TECHNICAL SPECIFICATION CHANGE REQUEST NO. 70

This proposal revises the RPS setpoints, safety limits, and operating limits, allowing operation of Crystal River 3 at 2544 MW thermal.

FIGURE 2.1-1
REACTOR CORE SAFETY LIMIT

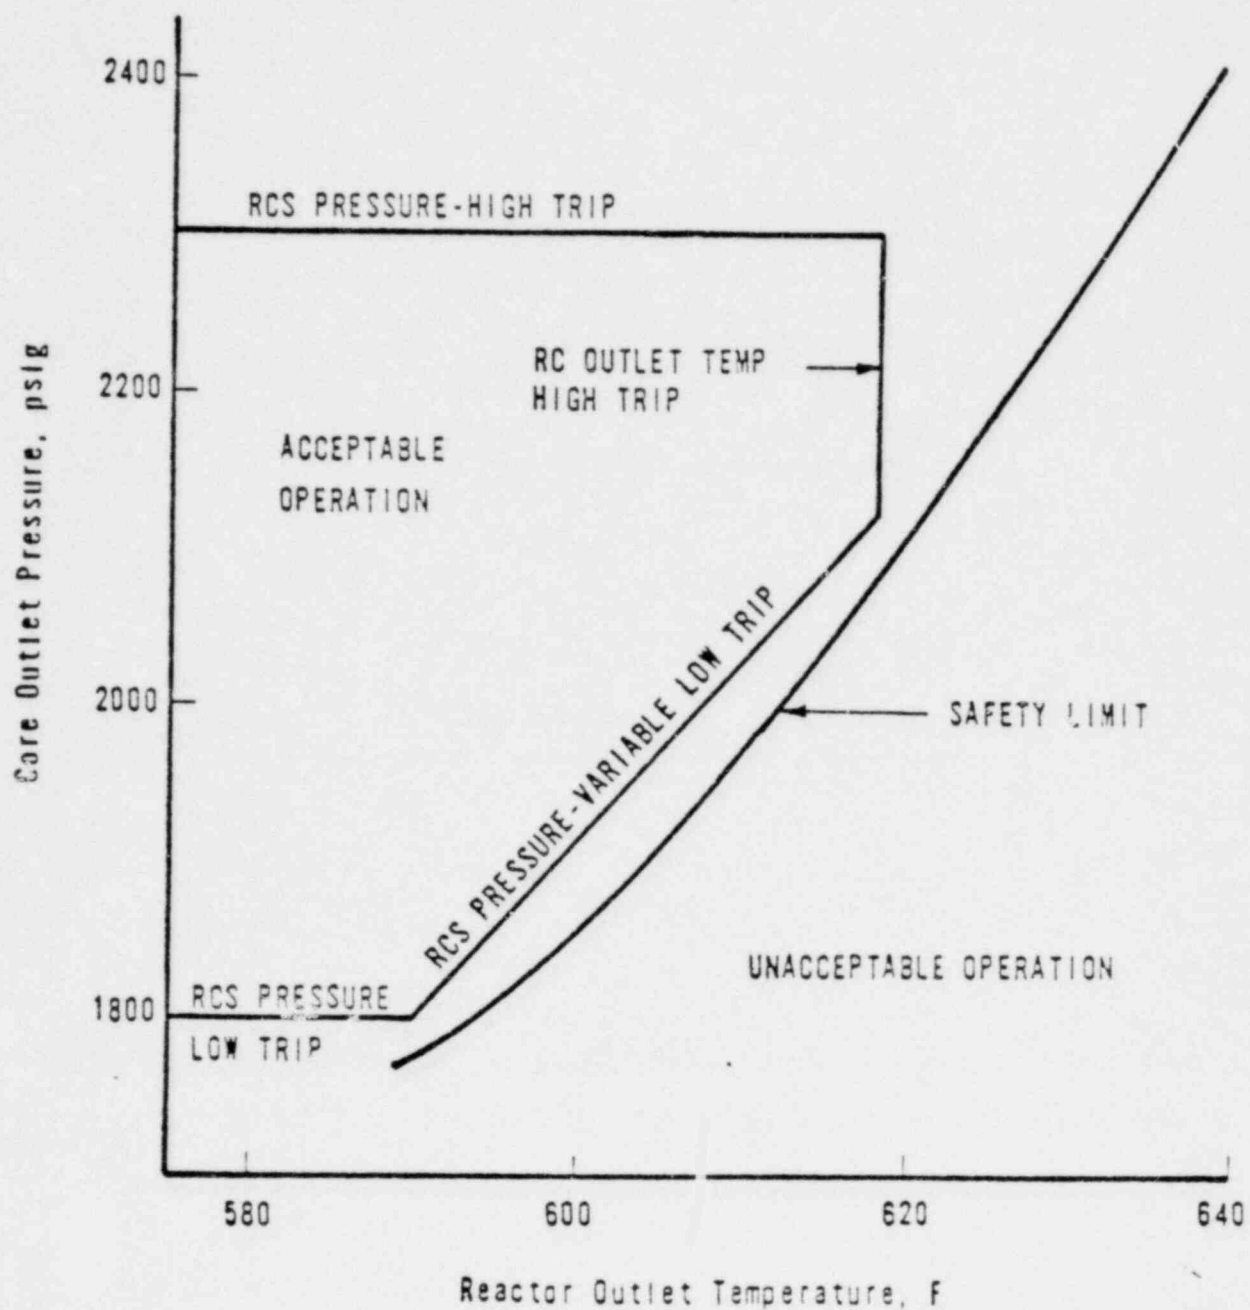
During Babcock & Wilcox' review(s) of BAW-10003 (environmental qualification of B&W supplied equipment) in response to IE Bulletin 79-01B, it was determined the RPS instrument string errors exceeded those originally assumed in the various safety analyses. Our letter of 4/9/81 (P. Y. Baynard to J. F. Stolz) described our program to resolve the issue. These changes are the end result of those efforts.
